**Recommendation to hold a public hearing and approve the Preliminary Plat for the subdivision of an existing 10,319 sq ft lot located at 371 W 7th Street (Apple Park Subdivision: Block 1: Lot 1) in the General Residential Low Density (GR-L) Zoning District into two townhouse sublots.**

**STAFF REPORT  
KETCHUM CITY COUNCIL  
MEETING OF JUNE 17<sup>th</sup>, 2019**

**PROJECT:** Apple Park Townhomes Subdivision Preliminary Plat

**FILE NUMBER:** P19-030

Attachment B.  
Preliminary Plat

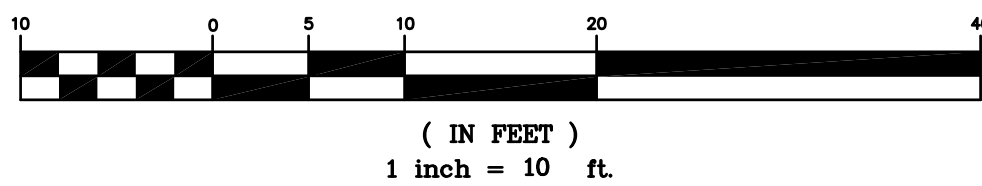
<b>Staff Comments</b>	<i>The preliminary plat indicates the attached garage of the dwelling unit accessed the 7<sup>th</sup> Street. The A-frame dwelling unit does include an attached or detached garage.</i>
<input checked="" type="checkbox"/>	<input type="checkbox"/>	<input type="checkbox"/>	16.04.030.C.1	The subdivider shall file with the administrator copies of the completed subdivision application form and preliminary plat data as required by this chapter.
			<b>Staff Comments</b>	<i>The application has been reviewed and determined to be complete.</i>
<input checked="" type="checkbox"/>	<input type="checkbox"/>	<input type="checkbox"/>	16.04.030.I	Contents Of Preliminary Plat: The preliminary plat, together with all application forms, title insurance report, deeds, maps, and other documents reasonably required, shall constitute a complete subdivision application. The preliminary plat shall be drawn to a scale of not less than one inch equals one hundred feet (1" = 100') and shall show the following:

<b>Staff Comments</b>	<i>This information has been provided within the application and indicated on the Preliminary Plat. The preliminary plat has been prepared by Bruce Smith, surveyor, Alpine Enterprises Inc.</i>
<input checked="" type="checkbox"/>	<input type="checkbox"/>	<input type="checkbox"/>	16.04.030.I .4	Legal description of the area platted.
			<b>Staff Comments</b>	<i>This standard has been met. The proposed legal description will be Apple Park Townhomes: Sublots 1 &amp; 2.</i>
<input checked="" type="checkbox"/>	<input type="checkbox"/>	<input type="checkbox"/>	16.04.030.I .5	The names and the intersecting boundary lines of adjoining subdivisions and parcels of property.
			<b>Staff Comments</b>	<i>This standard has been met. The adjacent Zark Park Subdivision and Ketchum Townsite Block 72 alley have been indicated on the plat.</i>

<input type="checkbox"/>	<input type="checkbox"/>	<input checked="" type="checkbox"/>	<b>16.04.030.I .6</b>	<b>A contour map of the subdivision with contour lines and a maximum interval of five feet (5') to show the configuration of the land based upon the United States geodetic survey data, or other data approved by the city engineer.</b>
			<b>Staff Comments</b>	<i>This standard is not applicable to the subdivision of an existing lot into two townhouse sublots.</i>
<input checked="" type="checkbox"/>	<input type="checkbox"/>	<input type="checkbox"/>	<b>16.04.030.I .7</b>	<b>The scaled location of existing buildings, water bodies and courses and location of the adjoining or immediately adjacent dedicated streets, roadways and easements, public and private.</b>
			<b>Staff Comments</b>	<i>This standard has been met. The existing dwelling units and adjacent street and alley ROWs are indicated on the Preliminary Plat.</i>

<input checked="" type="checkbox"/>	<input type="checkbox"/>	<input type="checkbox"/>	<b>16.04.030.I .8</b>	<b>Boundary description and the area of the tract.</b>
			<b>Staff Comments</b>	<i>The legal description appears on the proposed Preliminary Plat.</i>
<input checked="" type="checkbox"/>	<input type="checkbox"/>	<input type="checkbox"/>	<b>16.04.030.I .9</b>	<b>Existing zoning of the tract.</b>
			<b>Staff Comments</b>	<i>The existing zoning of the tract is indicated in Plat Note #4.</i>
<input checked="" type="checkbox"/>	<input type="checkbox"/>	<input type="checkbox"/>	<b>16.04.030.I .10</b>	<b>The proposed location of street rights of way, lots, and lot lines, easements, including all approximate dimensions, and including all proposed lot and block numbering and proposed street names.</b>
			<b>Staff Comments</b>	<i>No new streets are proposed. The dimensions of proposed Sublots 1 and 2 are indicated on the plat.</i>

<b>Staff Comments</b>	<i>The Preliminary Plat indicates the adjacent Zark Park Subdivision and adjacent 7<sup>th</sup> Street and alley ROWs.</i>
<input type="checkbox"/>	<input type="checkbox"/>	<input checked="" type="checkbox"/>	<b>16.04.030.I .18</b>	<b>The boundaries of the floodplain, floodway and avalanche zoning district shall also be clearly delineated and marked on the preliminary plat.</b>
			<b>Staff Comments</b>	<i>There is no floodplain, floodway, or avalanche zone on the subject property.</i>
<input type="checkbox"/>	<input type="checkbox"/>	<input checked="" type="checkbox"/>	<b>16.04.030.I .19</b>	<b>Building envelopes shall be shown on each lot, all or part of which is within a floodway, floodplain, or avalanche zone; or any lot that is adjacent to the Big Wood River, Trail Creek, or Warm Springs Creek; or any lot, a portion of which has a slope of twenty five percent (25%) or greater; or upon any lot which will be created adjacent to the intersection of two (2) or more streets.</b>

1. The Covenants, Conditions, and Restrictions (CC&R's) shall be simultaneously recorded with the final plat, and the City will not now, nor in the future, determine the validity of the CC&R's.

3. The recorded plat shall show a minimum of two Blaine County Survey Control Monuments with ties to the property and an inverse between the two monuments. The Survey Control Monuments shall be clearly identified on the face of the map.
